REMARKS

Claims 21-42, 45 and 46 were pending in the Application. Claims 21, 22, 31-33, 42, 45, and 46 were amended. Claims 21-42, 45 and 46 are now pending in the application.

ANNOTATED MARKED-UP DRAWINGS

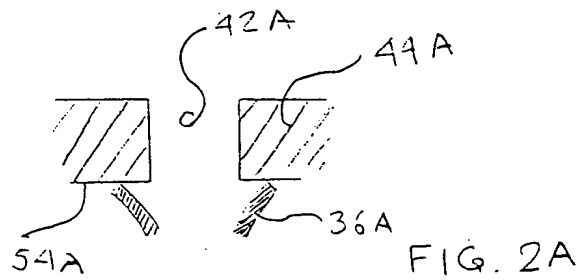
1. Annotated marked-up Drawings and Replacement Sheet designating Figures 1A and 2A as prior art have already been submitted with the Preliminary Amendment dated December 5, 2003. However, they are hereby re-submitted for the convenience of the Examiner. It should be noted that correction was also made regarding the reference character 12A to be 14A (upper side of the head of the fastener 10A), of 14A to be 16A (lower side of the head of the fastener 10A), and the addition of 12A to designate the head of the fastener 10A, as well as the addition of 40A to designate the front part of the barbs 36A. The Amendment regarding the correction of the reference characters finds support in Figure 1, wherein all reference characters designating miscellaneous elements are the same for respective elements in Figure 1A, with the difference the letter "A" follows the reference character in Figure 1A.
